DESCRIPTIVE REPORT

Registry No. H11508

General Locality Ernest Sound and Eastern Passage

Sublocality Western Portion of Bradfield Canal

Figure 3. Charted (17360) 95 fathom sounding and surrounding soundings from BASE surface

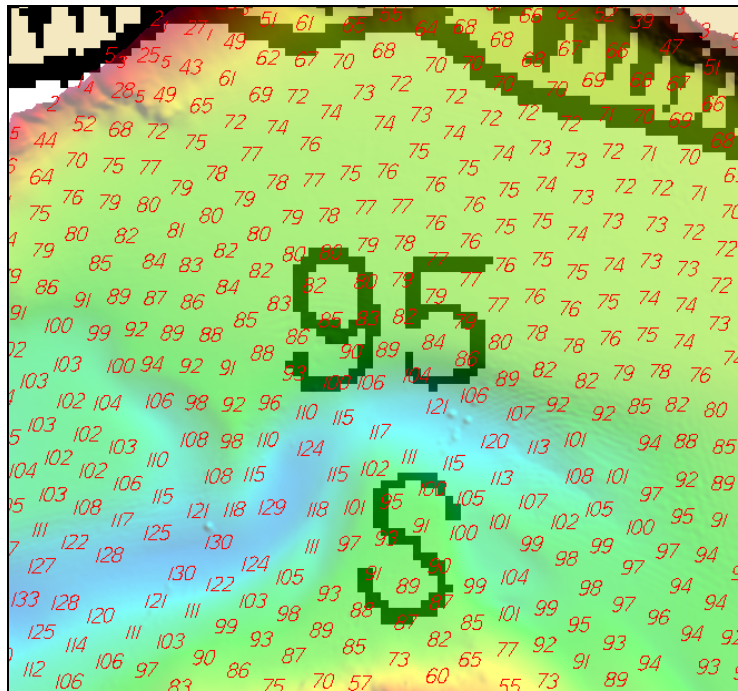
The 95 fathom sounding in the center of the sheet is not representative of the depths in the surrounding area (see Figure 3).¹²

¹² Concur.

Figure 4. Charted (17360) 154 fathom sounding and surrounding soundings from BASE surface

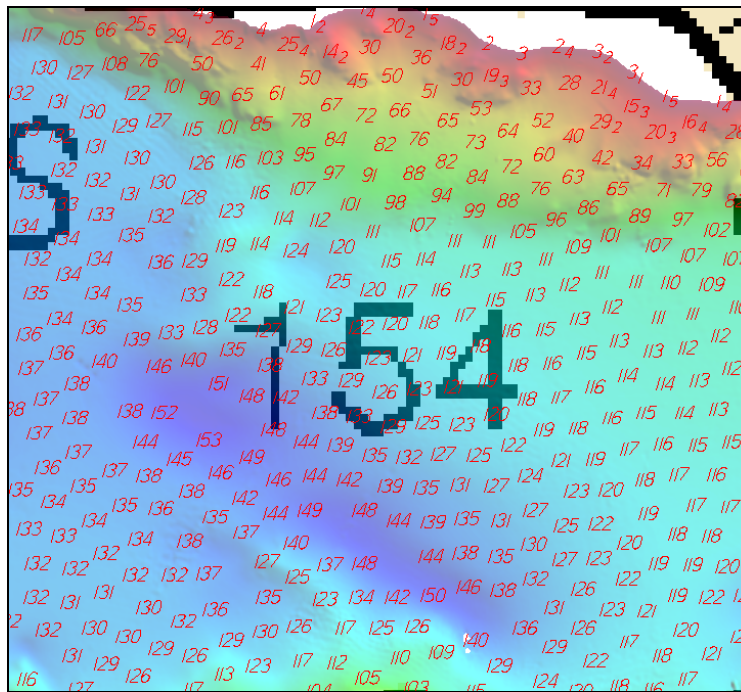
The 154 fathom sounding at the west end of the sheet is not representative of the depths in the surrounding area (see Figure 4).¹³

¹³ Concur.

Figure 5. Charted (17385) soundings near the north east corner of the sheet and surrounding soundings from BASE surface

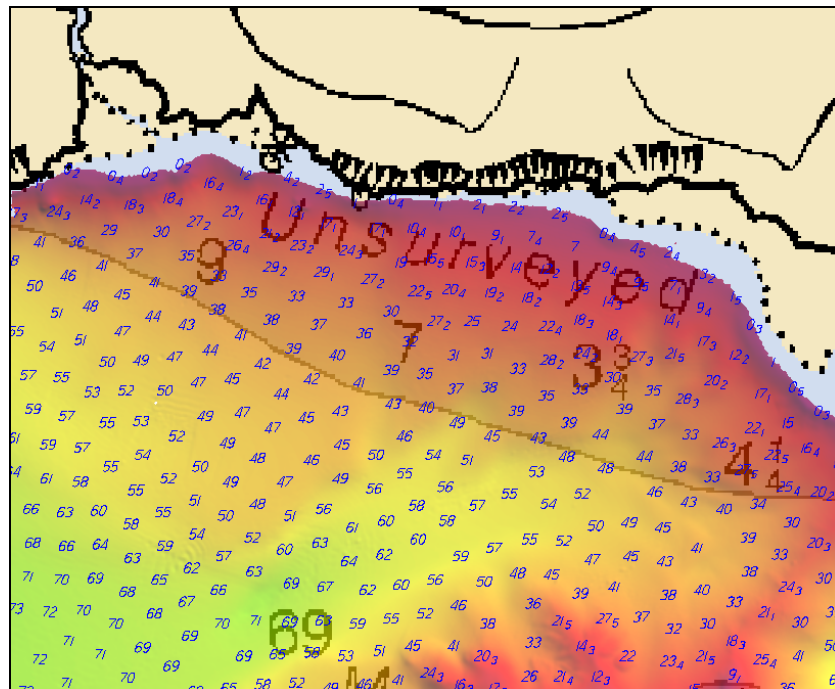
The soundings near the Unsurveyed area at the north east corner of the sheet are significantly shoaler (~20 fathoms) than depths from survey H11508 (see Figure 5).¹⁸

¹⁸ Concur.

Figure 6. Charted (17385) 96 fathom sounding and surrounding soundings from BASE surface

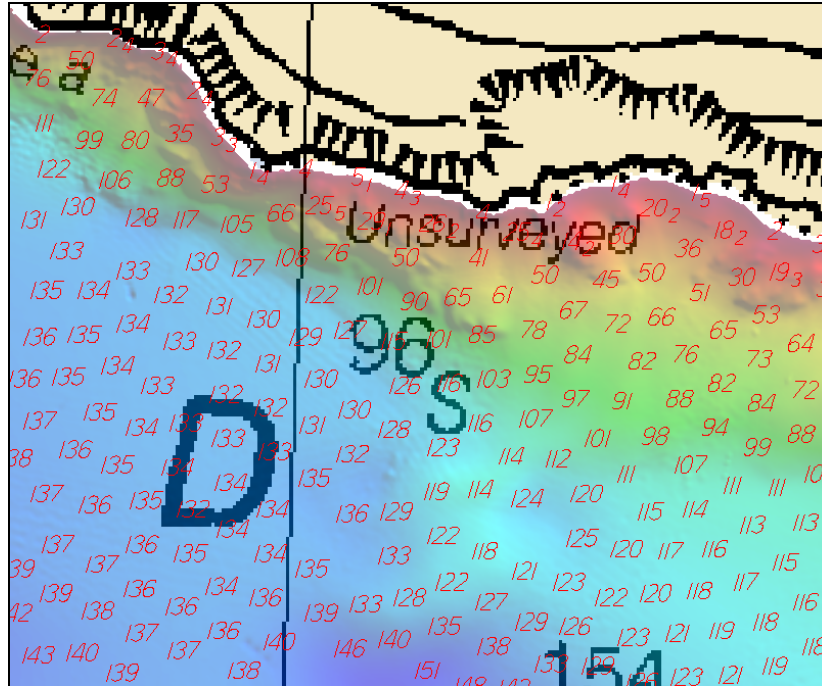
The 96 fathom sounding at the west end of the sheet appears to have been pulled off shore for cartographic representation (see Figure 6).²¹

²¹ Concur with clarification. The surrounding depths suggest that the generalization is very minor. There is a surveyed 94 fathom sounding 113 meters to the north of the charted 96 fathom sounding.

Figure 7. Revised depth and location of submitted DTON.

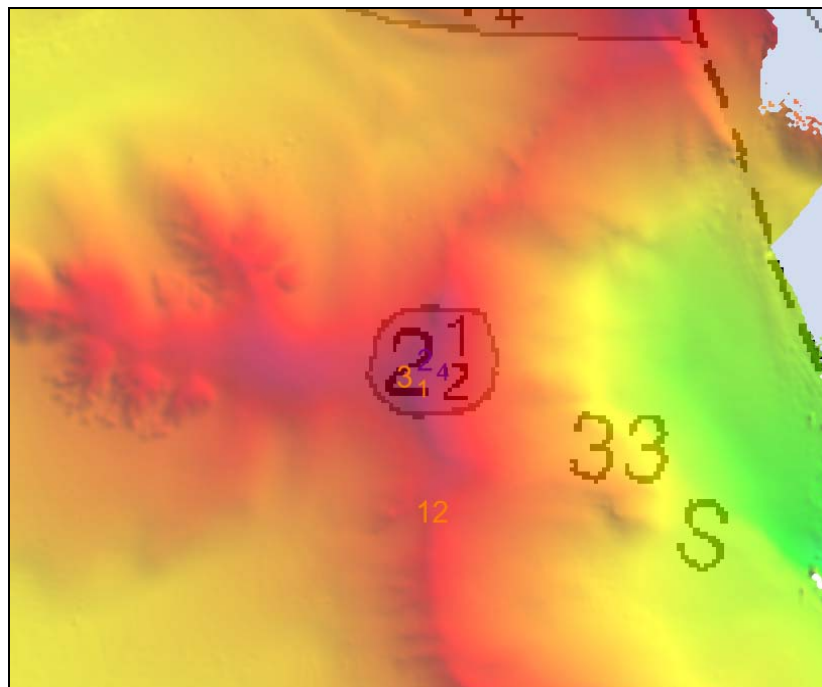
One danger to navigation (DTON) was found and reported to the Mapping and Charting Division for verification and final submission to the Seventeenth Coast Guard District on October 11, 2005.²⁵ A copy of the preliminary Danger to Navigation Report is included with the Pydro Preliminary Smooth Sheet (PSS).²⁶ The DTON was included in U.S. Coast Guard District 17 Local Notice to Mariners 44/05 (Nov 3, 2005).

Upon further Hydrographer review of additional data and the application of smooth tides, the DTON should be re-charted at location 56°12'05.679" N, 131°41'44.797" W with a depth of 5.79 meters (3.17 fathoms). An additional DTON was not submitted due to the new depth being slightly deeper than the original DTON reported depth.²⁷

²⁶ The depth of the reported DTON has been modified since submission. During the survey acceptance review, the new depth was determined, but a new report was not submitted since the new depth is deeper than the original reported depth. The new depth is depicted in HCell H11508. See DTON section of attached Features Report.

²⁷ Concur (see endnote 25).
